Amendments to the Drawings

Prasad Y. Chebrolu
LOW-IMPACT METHOD AND APPARATUS FOR MAINTAINING NETWORK ACCESS SERVERS
Attorney Docket No. 2705-092/Application No. 09/431,357

FIG. 1

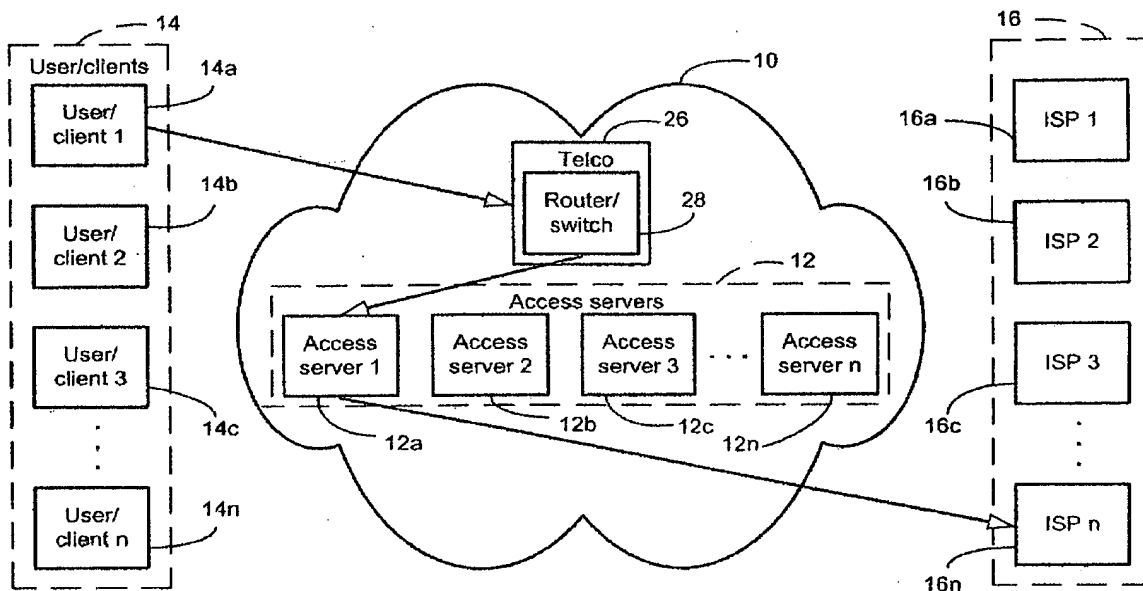
The drawings were objected to as failing to show an access server having associated channels carrying incoming digital or analog traffic, and the determining if existing calls are below a predetermined usage threshold and the subsequent migration of those calls to other network access servers.

Figure 1 has been changed to show that the network access server receives both digital and analog calls, and Figure 4 has been changed to show both the designation of channels as idle when the usage falls below the specification, as well as the migration of existing calls. The specification has been amended to refer to these changes in Figure 4. These amendments do not constitute new matter, as they are supported by the specification in several places, among them page 4. The changes to the drawings are designated by a circle, which will be removed in the formal drawings, only being used here to show the changes.
